BELLANCA AIRCRAFT CORP.

SERVICE LETTER NO. 39 MARCH 8, 1967

SUBJECT: PILOT RUDDER PEDAL REPLACEMENT

Figure 1: R/N 184153 Drag Strut Fitting Critical Inspection Areas

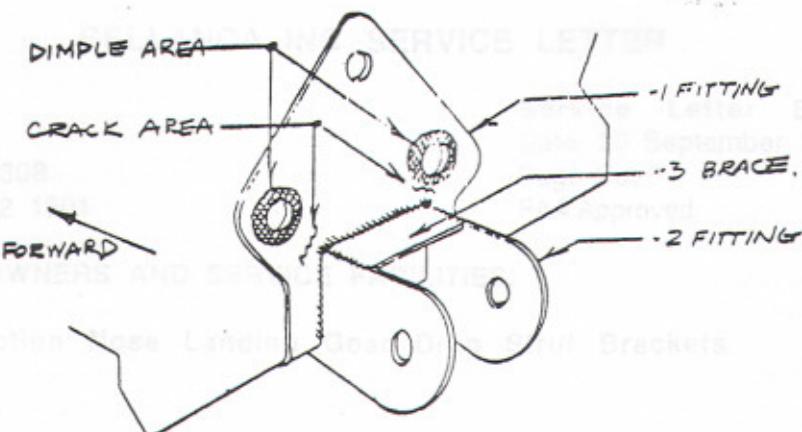
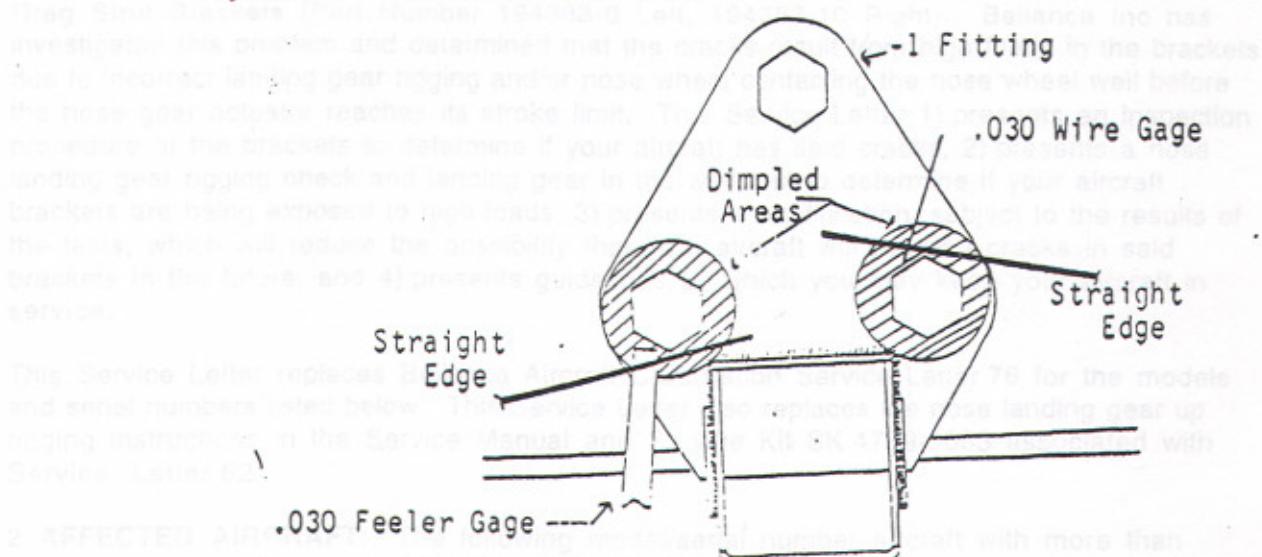
Bellanca recommends that the MLG Front Spar Drag Strut Fitting be inspected for cracks and local deformation as follows...Place jacks under the aircraft. Do not apply loads to the landing gear components, particularly the drag strut, as it is possible to move the drag strut to overcenter and cause the landing gear to collapse. Figure 1 describes the 194153 fitting parts. Clean the aft face of the -1 Fitting with Stoddart solvent and a brush. Inspect for cracks adjacent to the welds which join the -1 Fitting to the -2 Fitting and -3 Brace near the lower aft attachment bolt holes. Use liquid penetrant inspection technique and a magnifying glass. If any crack is found, replace the assembly with a new fitting assembly P/N 194153-30 or P/N 194153-40, as applicable, prior to further flight.

Lay a straight-edge alongside the lower aft attachment bolts as shown on Figure 2. Use an 0.030 inch gauge to look for evidence of local deformation (dimpling) in the -1 Fitting. If any deformation greater than 0.030 is found, replace the assembly with a new fitting assembly P/N 194153-30 or P/N 194153-40, as applicable, prior to further flight.

Figure 1: Critical Inspection Areas
(View Looking Up and Aft)

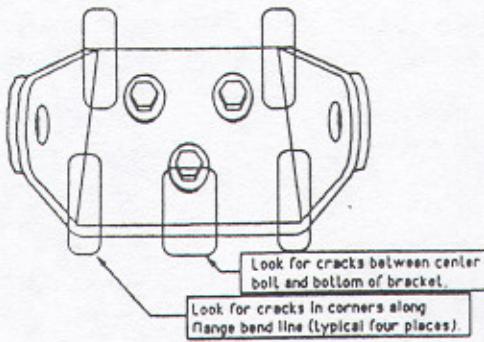
Place the aircraft on jacks with wheels off the ground. The NLG Drag Strut Brackets are located on the forward side of the firewall and attach the nose landing gear drag strut to the fuselage primary structure at Fuselage Station 1. Remove the bolts attaching the drag struts to the brackets. Thoroughly clean the brackets in-place. Visually inspect the brackets for cracks with a ten power magnifying glass concentrating in the areas shown in figure 1, ie: below the center bolt and along the flange radius. If cracks are found, replace the brackets with new parts (PN 194650-0 right side, PN 194383-0 left side) using the alignment procedure described in Section 5: Installation New Brackets.

Figure 2: Dial Indicator Set-up (Model 17-30A Shown)

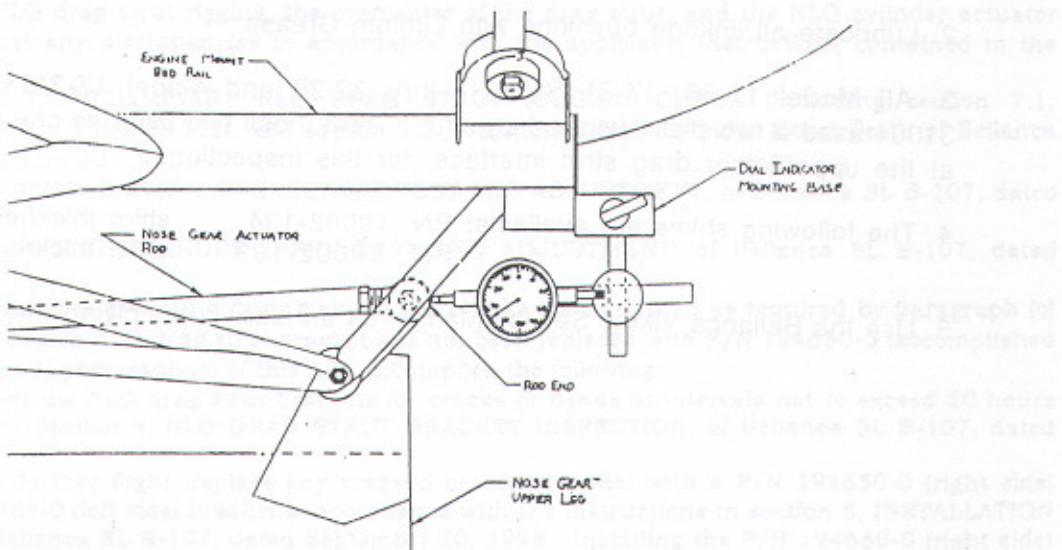
Slowly retract the landing gear until the nose wheel just touches the wheel well using the following procedure: 1) place landing gear switch in the up position, 2) locate an observer at the nose gear, 3) turn master switch on until nose wheel moves to approximately 12 inches from contacting the nose wheel well, 4) jog the master switch until the wheel is within inches of touching the well, 5) manually move the nose wheel and/or the main gear (pull main gear down to move nose wheel up) until the nose wheel just touches the well. It should be possible to turn the wheel with one hand noting some friction between the wheel and the well. Warning - do not allow the pump to move the nose wheel to contact the well and develop up pressure; failure to do so may cause excessive loads and damage the drag strut brackets. Install a dial indicator to measure motion between the nose gear cylinder and cylinder rod as illustrated in figure 2.
